**UNDERGROUND STORAGE TANK REMOVAL AND
ABOVEGROUND STORAGE TANK INSTALLATION
IFB NO. 310315-FY16-23**

**Addendum #2
May 20, 2016**

ACT-100® Double-Wall Underground Steel Storage Tanks

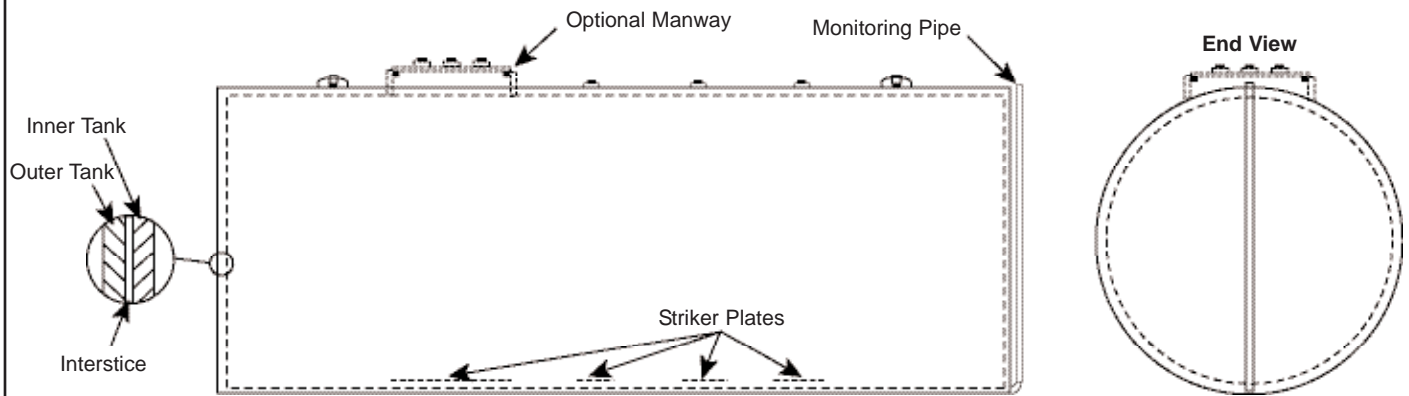
Question 1: I would like to submit the following information for your consideration as acceptable alternates to the spec'd Aboveground Storage Tank (AST) and Oil Water Separator (OWS). Please see the attached brochures as well as written description below.

The oil water separator is a UL-2215 system, which we also fabricate exactly, but for the shell material. Our oil water separator would be a carbon steel double wall tank, with 100 mils of Fiberglass on the exterior per our ACT-100 underground tank standard, and the interior would be coated with two coats of epoxy following the Steel Tank Institute Aquasweep Standard for Oil Water Separators. See page 4 of our OWS brochure.

The Town will accept any oil water separator (OWS) that meets the minimum requirements of the equipment referenced in the advertisement. The Town will not accept any proposed OWS that requires the installation of anodes.

Aboveground Tanks UL-142 Single Wall

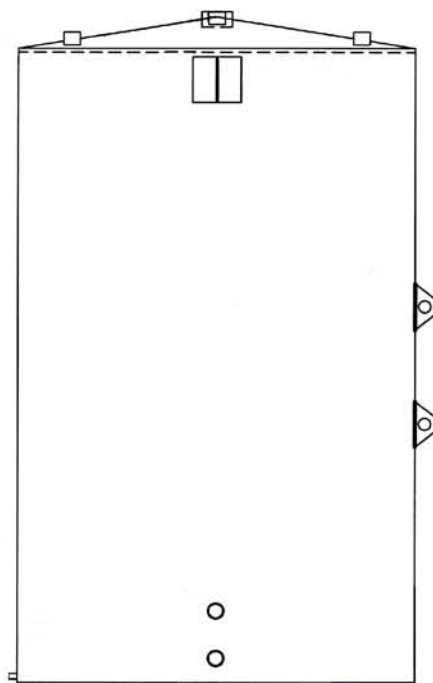
Our UL-142 storage tanks come in both single wall and double wall design. The referenced / spec'd Safe-T- Tank is just a single wall rectangular, UL-142 which we manufacture as well. We can provide the exact item and even offer a double wall option.

Answer 1: The Town will require any aboveground storage tank (AST) to meet UL-142, double wall construction, stainless steel, vented per code, have all necessary ports for monitoring, filling and evacuation, and 5 gallon recessed spill box for manual fill with debris screen for both waste oil and antifreeze. And have a maximum 36" lift over height. 500 gallon used oil capacity, and 100 gallon used antifreeze capacity.
